# **RULES FOR THE SURVEY AND CONSTRUCTION OF STEEL SHIPS**

**Ships Carrying Liquefied Gases in Bulk**

**2007      AMENDMENT NO.1**

**2007 AMENDMENT NO.2**

**Fig N3.5.1 Access for Inspection of Insulation ( mm )**

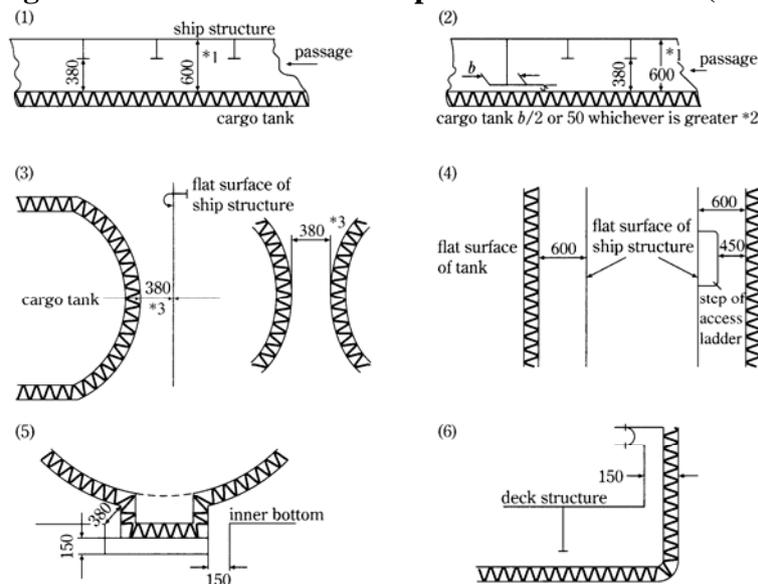
Fig N3.5.1 has been amended as follows.

- \* 1: This distance between the surface to be inspected and the surface to which above structural elements are fitted, e.g. deck, bulkhead or shell, should be at least 450mm in case of a curved tank surface (e.g. in case of C-tank).
- \* 2: Where the surveyor does not require to pass between the surface to be inspected and any part of the structure.
- \* 3: Where the surveyor does not require to pass between that curved surface, a smaller distance than 380mm may be accepted taking into account the curved surface.

- 1) If necessary for inspection, fixed or portable staging should be installed. This staging should not impair the distances required above (1) to (4).
- 2) If fixed or portable ventilation ducting has to be fitted in compliance with 1.2.2, Part N of the Rules, such ducting should not impair the distances required above (1) to (4).
- 3) If there is no suction well, notwithstanding figure (5) above, the distance between the cargo tank sump and the inner bottom may be reduced to 50 mm.
